PLANNING MEMORANDUM

To	Gina Sweetman, Chair of Hearing Panel, Amy Robinson, Hearing Panel Member and Megan McKay, Hearing Panel Member	From	Jess Bould Town Planning Group on behalf of Christchurch City Council as applicant
Copy	Janice Carter, Consultant Processing Officer on behalf of Christchurch City Council Olivia Murray, Consent Processing Officer, Canterbury Regional Council	Reference	3407-25
Date	5 November 2025	Pages	4 + Attachment
Subject	Summary of Changes to Application: RMA2023/3243 and CRC242267, CRC242268, CRC242269 and CRC251999

SOUTHSHORE EDGE PROTECTION
SOFT EDGE CONCEPT SKETCH
PLAN VIEW

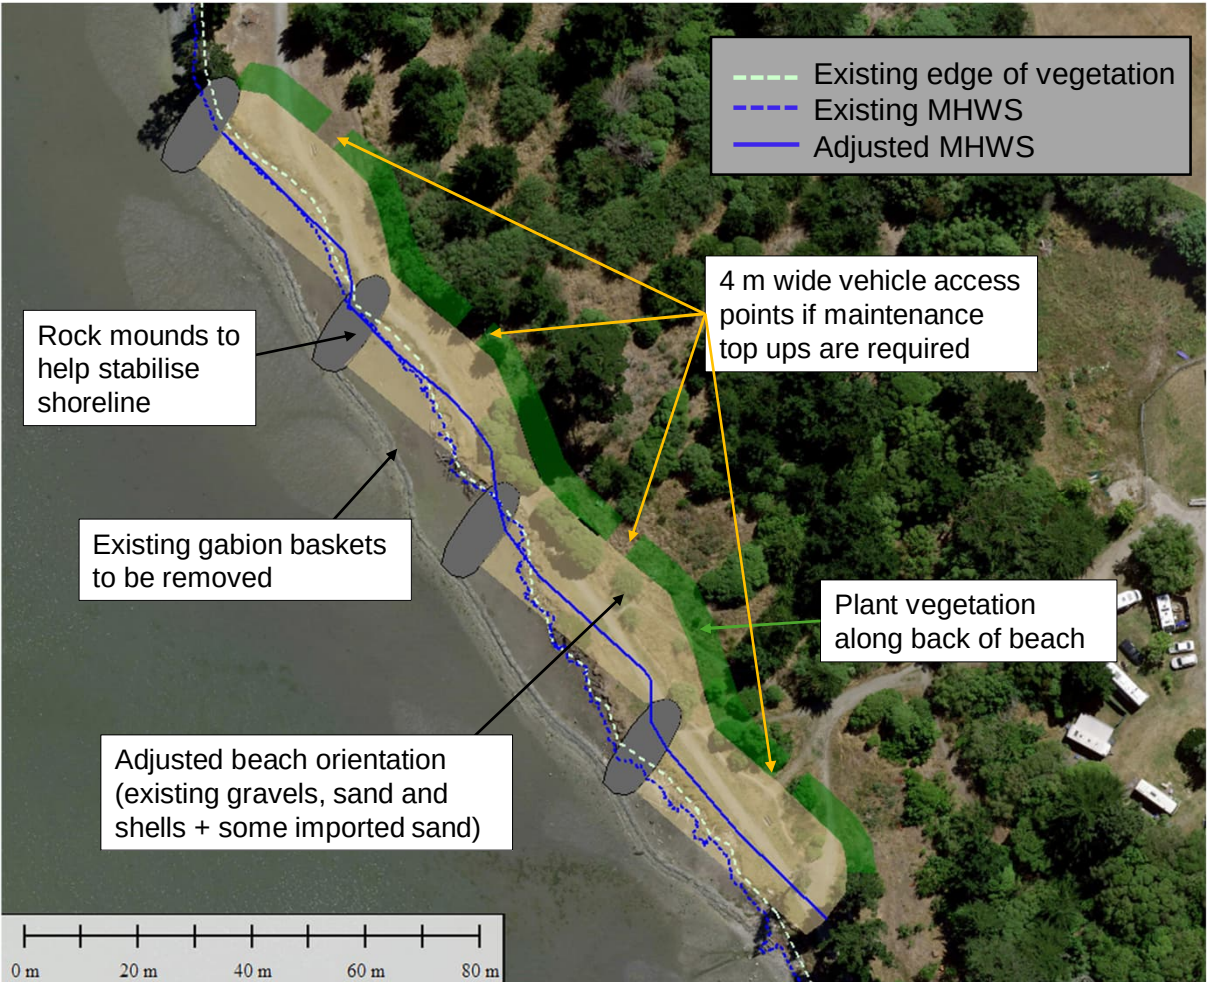
- Adjacent to 44A Rocking Horse Road, due to the proximity of the proposed shared pathway to the dwelling.
- Between CH0 and CH190 at South New Brighton Park, where gabions are required to protect a midden site, as requested by Mana Whenua.
- Adjacent to South New Brighton Park, between CH235 and CH405 where the soft beach area is proposed. Further development of this concept is occurring, with concept sketches included as **Attachment X**.

During a site visit with CRC technical specialists, the edge area adjacent to South Brighton Holiday Park was identified as a suitable location to implement an alternative edge protection solution. CRC indicated support for a 'soft edge', where the slope could be eased back to remove the erosion scarp, and planting introduced to further stabilise the edge. This location was identified as being suitable due to the large setback to the Holiday Park.

The Applicant has decided to progress the 'soft edge' for this part of the project. The original cobble beach option has been retained as a contingency option should the soft edge prove unsuccessful. Proposed consent conditions will include monitoring, reporting requirements and clear triggers for implementing the contingency plan. Further details and expert evidence on this approach will be presented as part of the hearing.
